#### MUNICIPAL PLANNING COMMISSION THURSDAY APRIL 6, 2017 – 12:30 PM TOWN OF REDCLIFF

- 1. CALL TO ORDER
- 2. ADOPTION OF AGENDA
- 3. DEVELOPMENT PERMIT APPLICATION FOR MPC CONSIDERATION
  - A) Development Permit Application 17-DP-019 Coral Contracting Lot 11-12, Block 6, Plan 1117V (717 1 Street SE) Semi-Detached Dwelling
- 4. ADJOURNMENT

## <u>Development Permit Application</u> <u>Background Information / Review</u>

SITE PLAN
Al SCALE: 1:200

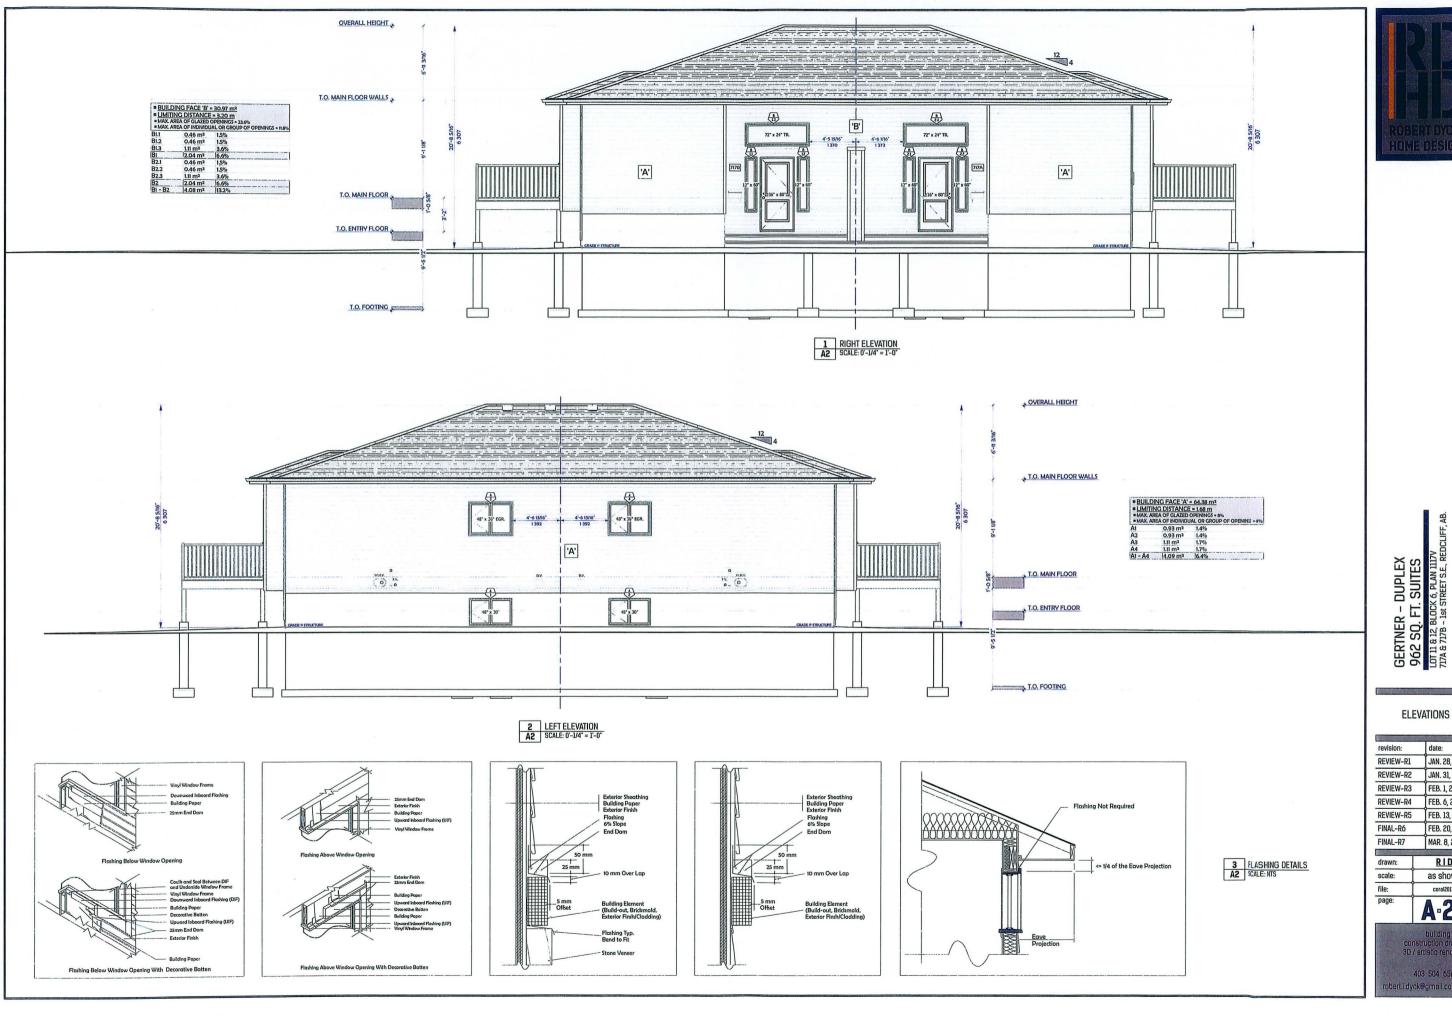
- The setbacks as shown on the Site Plan on the north, east, and south side of the building comply with the Land Use Bylaw;
- The site plan indicates that the front deck encroaches into the front yard setbacks by as much as 2.0 meters.

- Section 70.1 Projections into Minimum Setbacks states
  - a) Eaves, cantilevers, bay or bow windows, porches, verandas, balconies, cantilevers, shade projections, chimneys or unenclosed decks, may

project a maximum of 0.6 m over or onto a required front yard unless otherwise approved by the Development Authority

- The Applicant has not indicated how proper drainage will be achieved between the adjoining properties;
- The Land Use Bylaw requires two (2) parking spaces per unit. The submitted site plan shows adequate off street parking to comply with the Land Use Bylaw.

I have had a conversation with the Applicant and he has indicated that he is agreeable with moving the building back to meet the MPC's requirements.

- 1. The exterior of the Semi Detached Dwelling to be similar or compliment adjacent properties;
- 2. Prior to release of the Development Permit the Applicant shall:
  - a. Provide a site grading plan to the satisfaction of the Director of Planning & Engineering;
  - b. Provide a site plan showing a front yard setback complies with the MPC's decision, and is to the satisfaction of the Development Officer;
  - c. The Applicant shall pay a damage deposit in the amount of one thousand (\$1200.00). The deposit is to be used to repair any damage to the Town of Redcliff infrastructure (i.e. sidewalk, curb, gutter, curbstop) damaged by the Applicant, Applicant's contractors or suppliers.
- 3. Payment of Off-Site Levies in the sum of \$3220.02;
- 4. Provide to the Development Officer as built grades after the project is completed to ensure that approved grades were met.
